Technical Service Bulletin

TSB06-170-001A

SUBJECT: Engine Cooling- Mechanical Fan Drive V-Belt Alignment

APPLIES TO: Spartan K2 and K3 Chassis Models Equipped with a Mechanically Driven Engine Cooling Fan, Manufactured through September 22, 2005.

FIG. 3-1

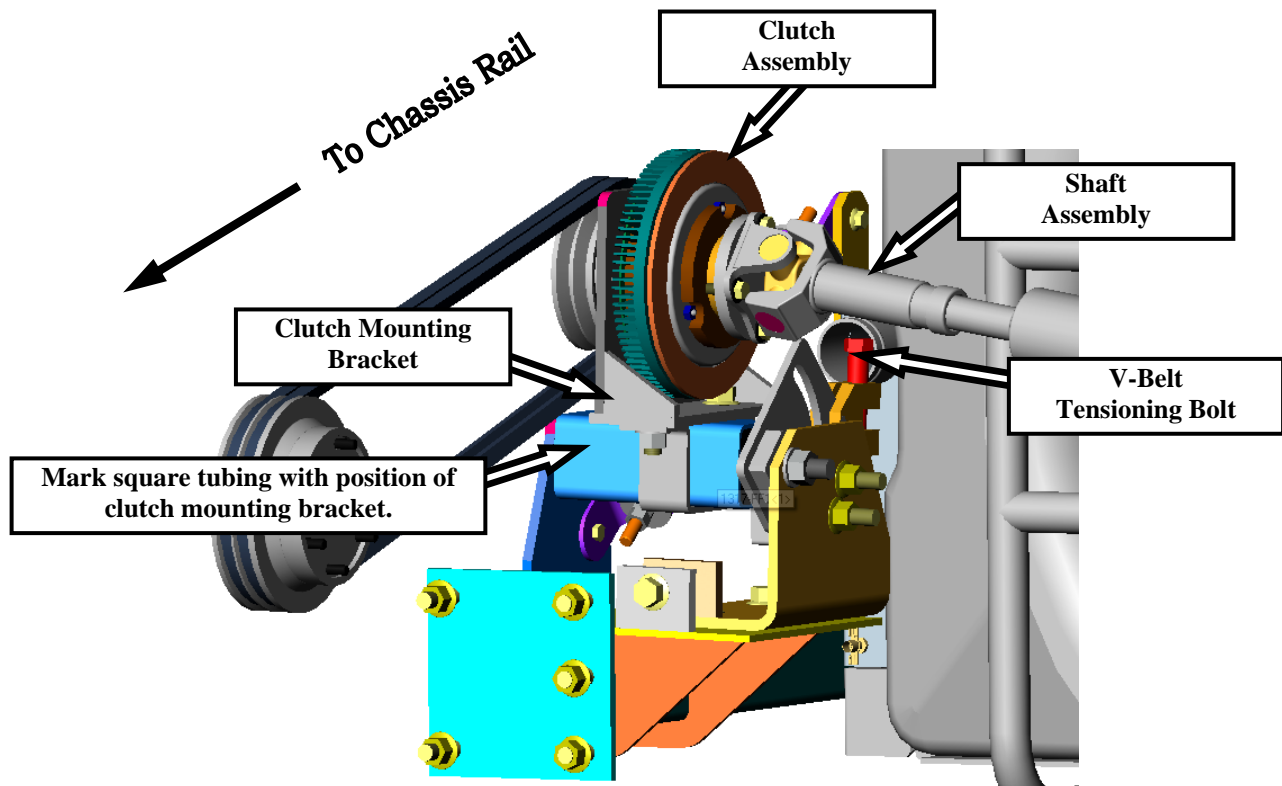
5. Refer to FIG. 3-1. Disconnect the shaft assembly from the clutch assembly by removing the (4) 7/16-20 bolts. Retain fastener hardware for reinstallation.

6. Refer to FIG. 3-1. Locate the square tube supporting the clutch mounting bracket. Mark the existing position of the clutch mounting bracket on the square tube using a permanent marking tool.

FIG. 4-1

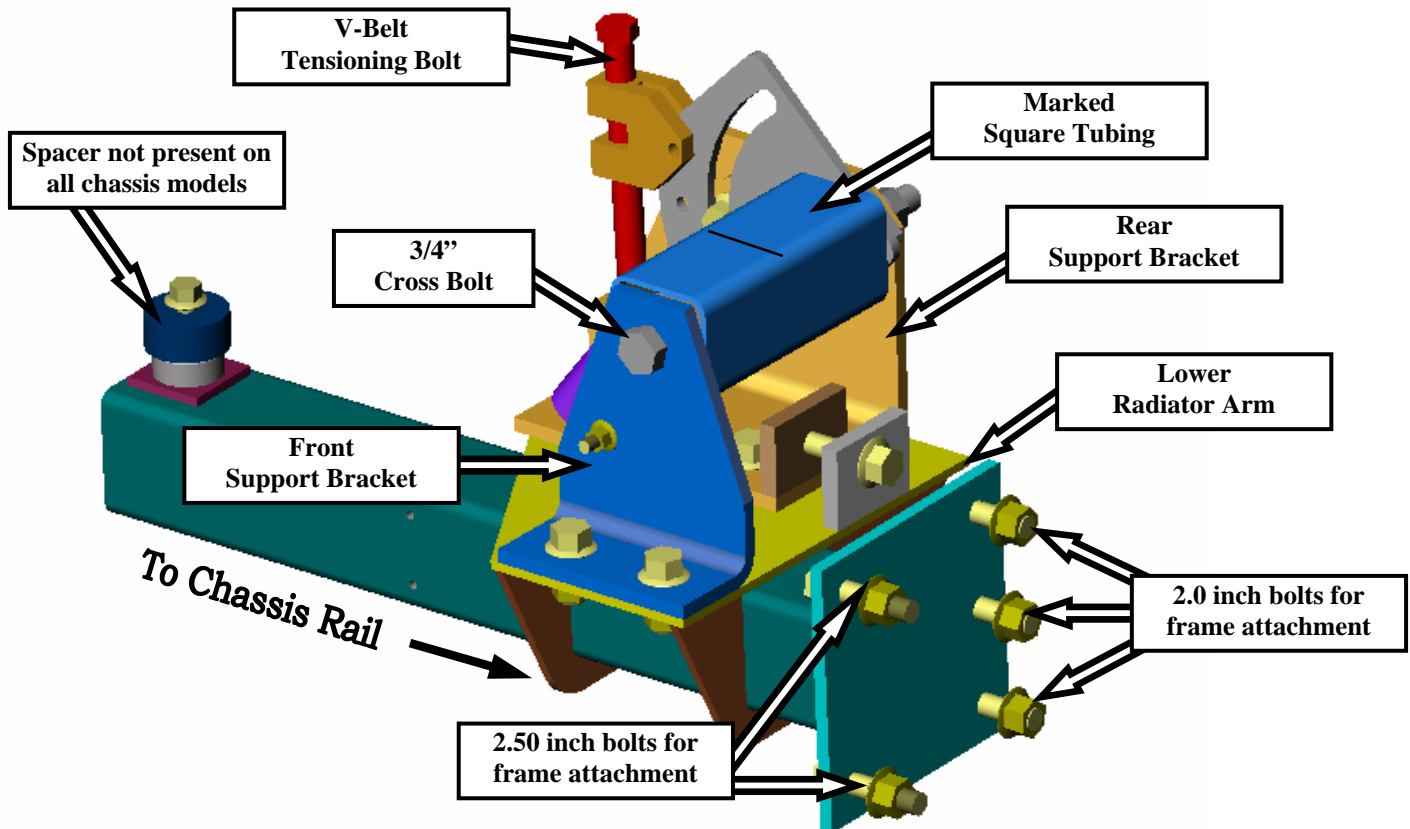
7. Remove the (2) 5/8-11 bolts, washers, and nuts attaching the clutch mounting bracket and remove the clutch mounting bracket/clutch assembly.
8. Disassemble components from the front and rear support brackets. Retain all hardware for reinstallation. Properly dispose of the rear support bracket.
9. Disassemble front support bracket from radiator arm. Retain bracket and fastener hardware for reinstallation.

11. Refer to FIG. 4-1. Install new radiator arm from kit by securing it to the frame with the (3) 5/8-11 x 2.00" bolts and the (2) 5/8-11 x 2.50" bolts. Torque to 180 lb. ft.
12. Refer to FIG. 6-1. Reassemble radiator mounting hardware. Torque to 85 lb. ft.
13. Refer to FIG. 5-1 and 8-1. Install new rear support bracket with (2) 5/8 -11 x 1.50" bolts locating the bolts in the bracket slots toward the chassis rail. **Do not torque at this time.**
14. Refer to FIG. 4-1. Install front support bracket and secure with (2) 5/8-11 x 1.50" bolts and nuts. Torque to 180 lb. ft.
15. Refer to FIG. 3-1 and 4-1. Reassemble components to the front and rear support brackets. **Do not torque at this time.**

FIG. 5-1

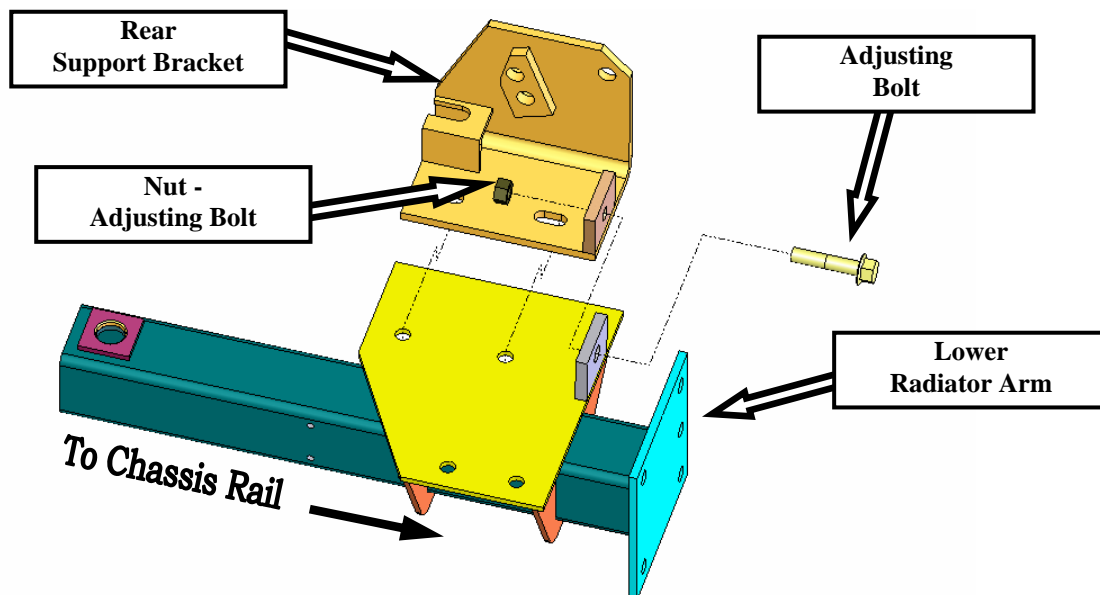
10. Disassemble the radiator attachments.

10a) Remove the 1/2" bolt from the radiator and the radiator mounting washers.

10b) Remove the bolts attaching the radiator arm to the frame. Properly dispose of the radiator arm.

PULLEY ALIGNMENT **INITIAL TENSIONING PROCEDURE** **FIG. 7-1**

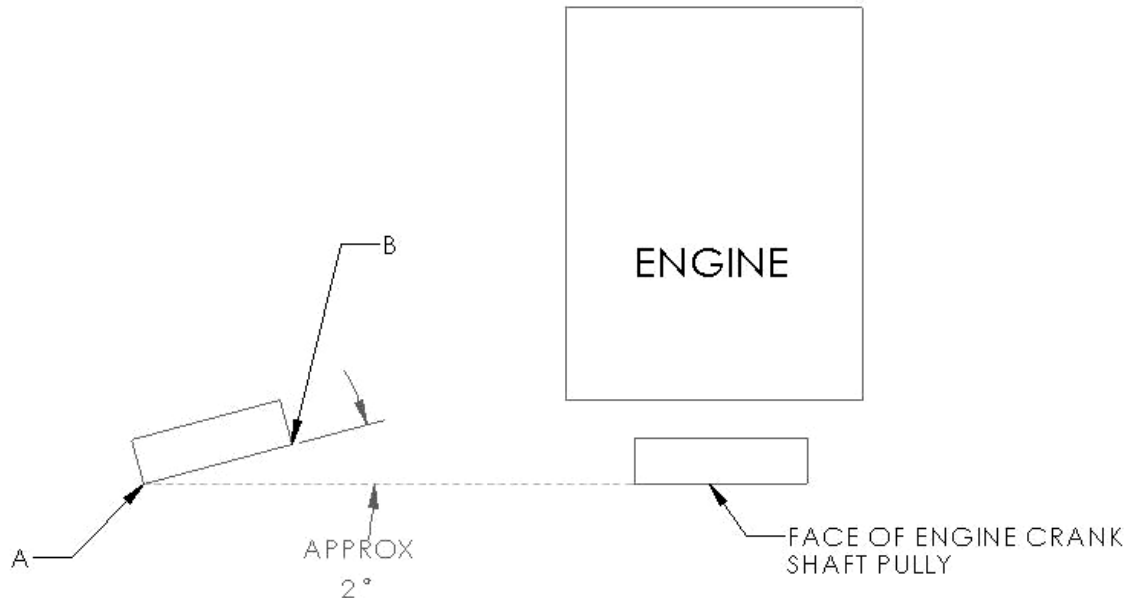
16b) Refer to FIG. 7-1. Locate clutch pulley for initial tensioning procedure. Align outer corner of clutch pulley (A) with face of engine crankshaft pulley while leaving inside corner of clutch pulley (B) slightly inboard of (A).

Check alignment with a straight edge from the crank pulley face to the clutch pulley face.

- 16c) Torque (2) 5/8-11 x 1.50" bolts to 180 lb. ft..
- 16d) Install belts.
- 16e) Tighten the tensioning bolt to approximately the correct belt tension by pushing downward in the middle of one belt. The belt should move only the distance of one belt thickness.
- 17. Reinstall shaft to clutch with (4) 7/16-20 x 1.25" bolts and flat washers. Torque bolts to 60 lb. ft.
- 18. Refer to FIG. 8-1 for final pulley alignment.

FIG. 8-1

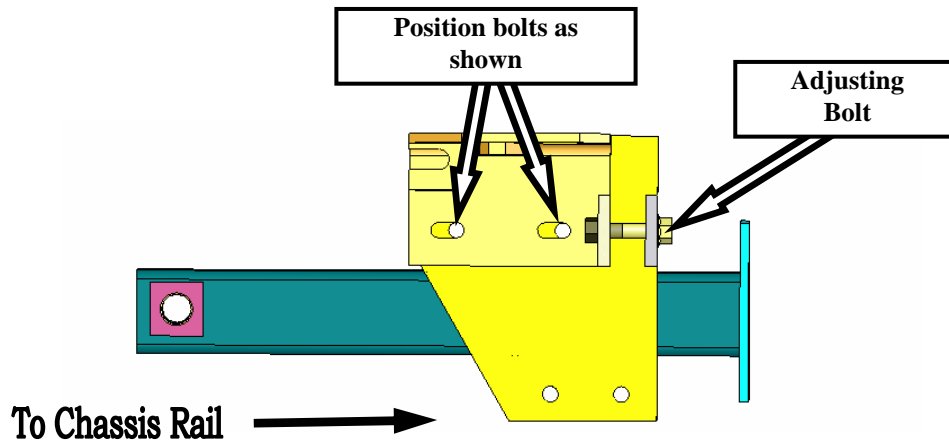
- 18a) Fine tune pulley alignment by laying a straight edge across both pulley faces and ensuring the faces are aligned with another.
- 18b) Align clutch pulley by moving the rear support bracket within the slots using the 5/8-18 adjusting bolt.

Note: If alignment cannot be achieved, the clutch bracket system may have to be moved along the axis of the square tube to assure pulleys can be aligned using the proper method.

- 18c) Torque the rear support bracket attachment bolts to 180 lb. ft.
 - 18d) After final adjustment using the 5/8-18 adjusting bolt, secure bolt in place with nut.
 - 18e) Torque the 3/4" cross bolt and the remaining (2) 5/8-11 bolts on the rear support bracket to 180 lb. ft.
- 19. Reconnect electrical wire for fan clutch.
 - 20. If new belts are installed, be sure to properly break-in by running engine for approximately 20-30 minutes, recheck tension, and adjust accordingly.
